ADDENDUM #2

Solicitation Number: 19-1252

Title: Building 50 - Laboratory Renovation, Rooms EW- 6, EW- 14, EW-15 and EW-16 - CEF, Ottawa. Date: December 17, 2019

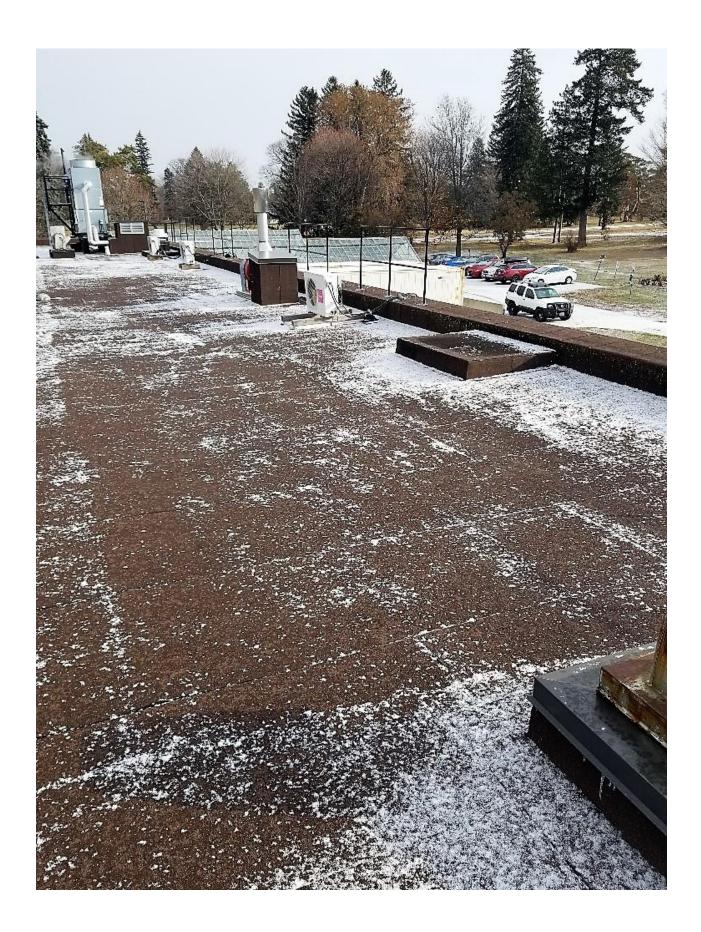
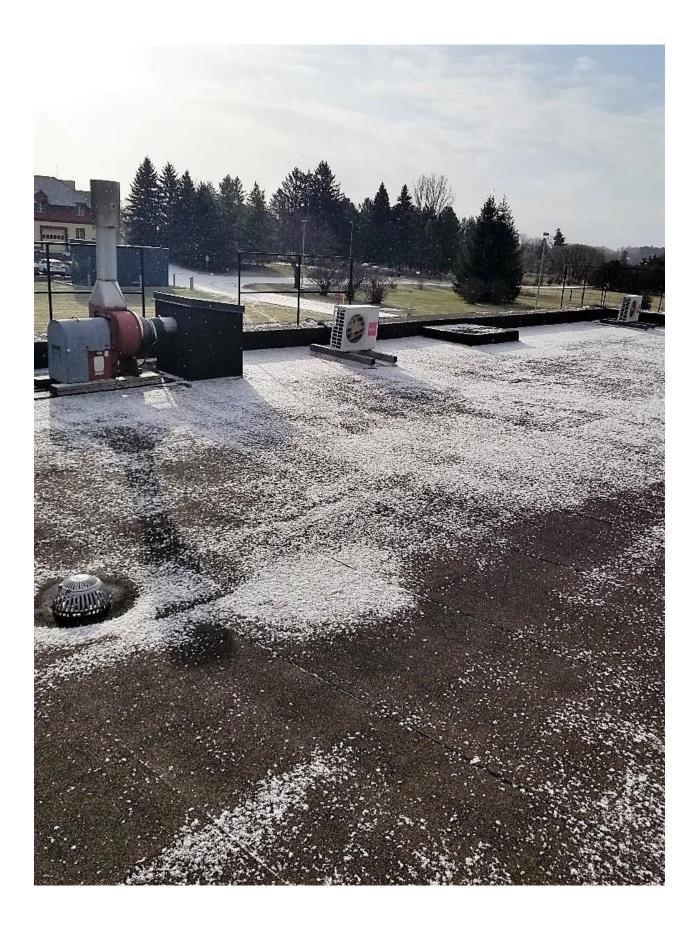
Q5. Roof pictures – please provide any roof pictures as there was not access during showing.

Q7. On Drawing M401, detail 5; Is the condenser steel support finish to be galvanized or painted?

- A5. See roof pictures below.
- Q6. Note 14 refurbish cabinets are the cabinets to be finished to match existing color, or is a new color required?
- A6. Refurbished cabinets to be repaired, primed and painted. Refer to General Notes sheet A-103.

A7. No preference for finish, both are acceptable. The most common pre-manufactured stands seen are the Quick-Sling which is powder coated and the EcoFrame which is electroplated zinc coated. The contractor may be choose to fabricate their own stand which is also acceptable.

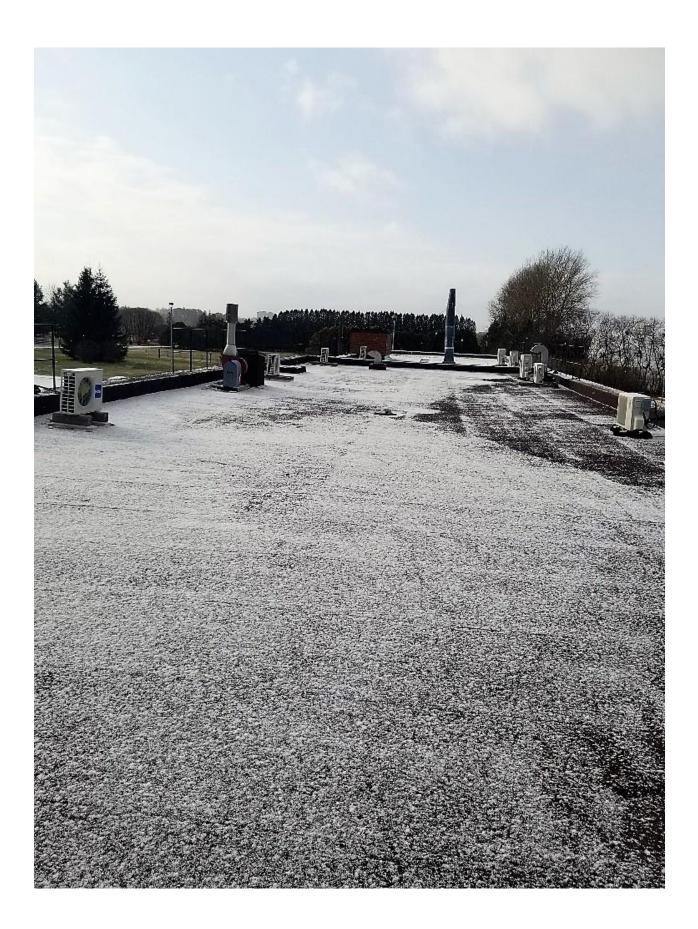
Q8. Can you please clarify roof structure under the rooftop unit on M301, detail 1?

- A8. Detail 1 on M301 is the standard air handling unit detail. The contractor should refer to the structural drawings for the roof structure. See similar details on SK4, that shows what is likely a more accurate depiction of the roof structure.

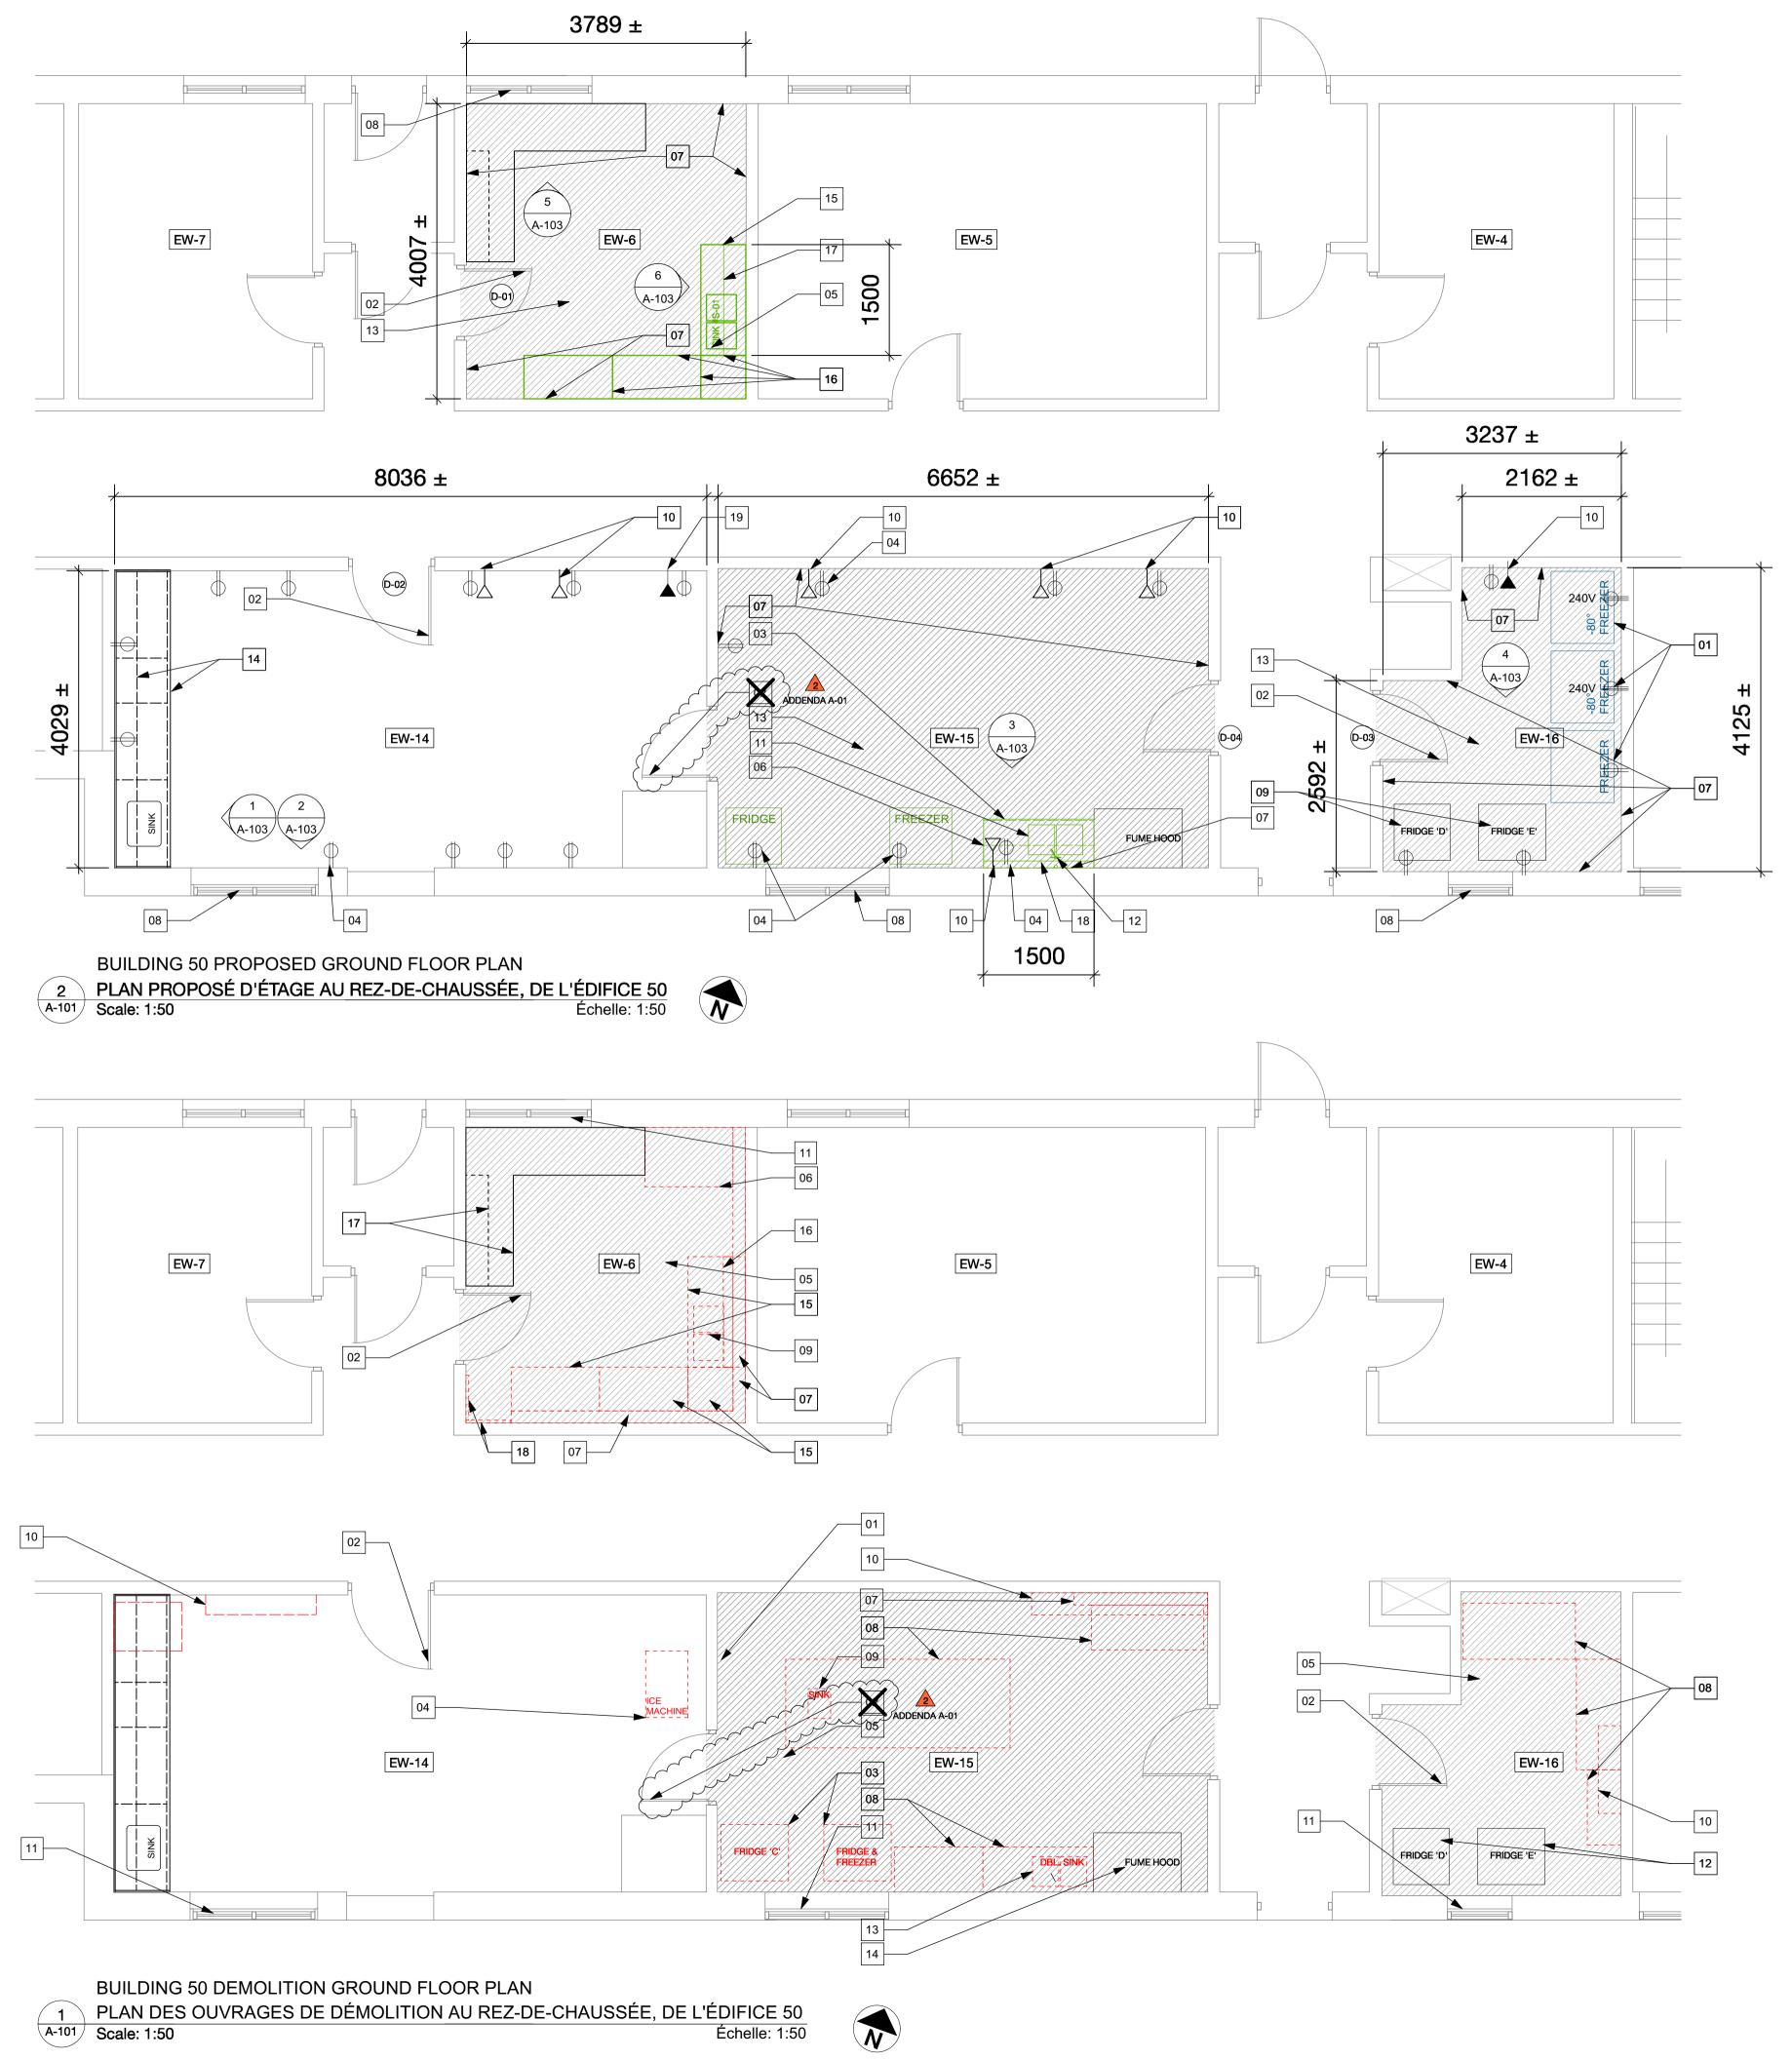
- 1. Sheet A-101:
 - a) Drawing 1/A-101: Delete keynote marker # 02 at door between room EW-14 and EW-15 as indicated.
- b) Drawing 2/A-101: Delete keynote marker # 02 at door between room EW-14 and EW-15 as indicated.
- c) Proposed Floorplan notes: Revise note #18 as indicated. See sheet A-101 below.

- 17. RE-INSTALL EXISTING SHELVING.
- 18. FURR OUT KNEE WALL- SEE 8/A-103. MUR NAIN, À AMÉNAGER AVEC DES PROFILÉS DE FOURRURE RESSORTANT. VOIR LE
- DÉTAIL 8/A-103.
